# XFMRS

PCN#:19051001

## Product Change Notice

XFMRS Ltd Announcement regarding change on tape & reel packing size for XFTPRH5D28R series

Description of change:

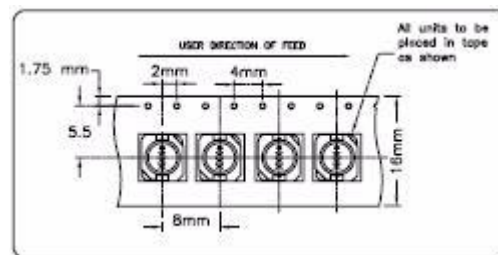
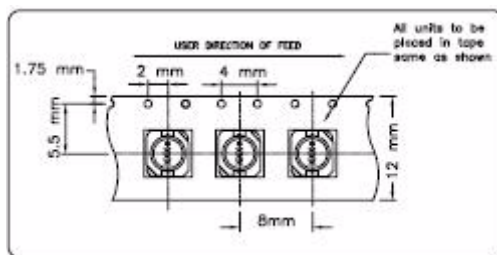
From:

To:

Std carrier tape of 12mm width

Std carrier tape of 16mm width

Reason of change". To improve packing robustness (peeling strength) by providing more sealing area to the carrier tape
